GLOBAL TECHNICAL BULLETIN

Ref No.: GTB2009016
Date: September 16, 2009

To: All Yanmar Marine Distributors
Subject: Oil level change for SD50 series

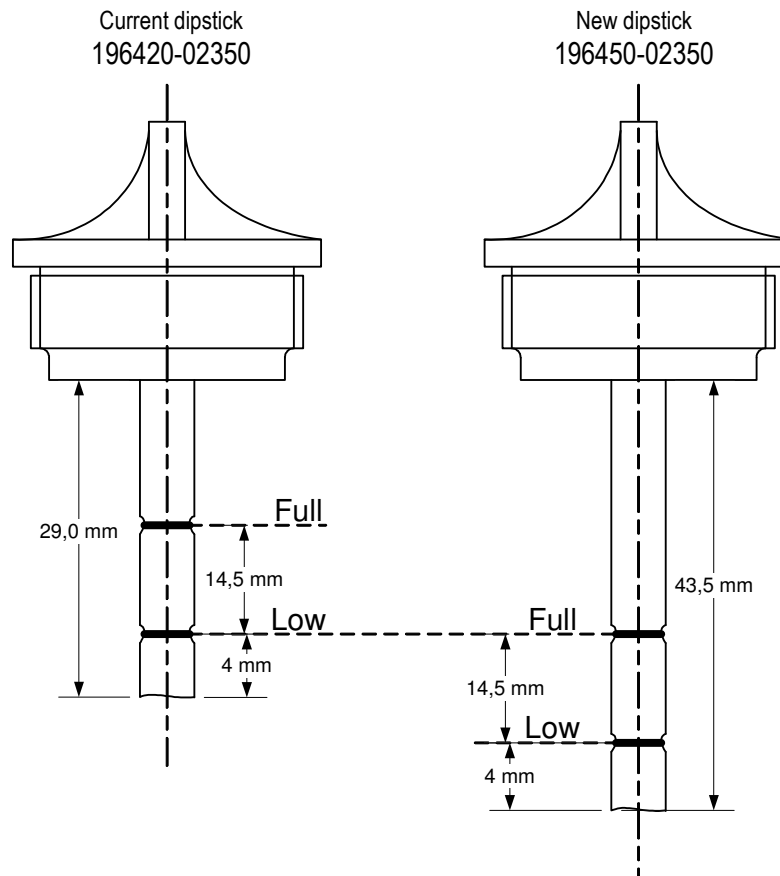
From our warranty-claim analysis, YMI has found some SD50 units with complaints regarding oil leakage at the input shaft, or where the oil was emulsified. YMI found that if our current oil-level is slightly exceeded, the inside pressure of the SD50 may exceed the proof leakage pressure for the oil seal. This can cause oil leakage at the input shaft during running, and it could suck water from the oil seal on the propeller shaft as well.

In order to obtain a lower oil pressure inside the drive, the maximum oil level has been changed from full position to low position on the dipstick.

[The difference is 14.5 mm on the dipstick]

The part number of the dipstick of the SD50 series has been changed from 196420-02350 to 196450-02350

Remarks: Dipstick is very short, so no possibility to put new low-level mark on current dipstick. Please use current low-level mark as new high-level mark for correct oil-level.
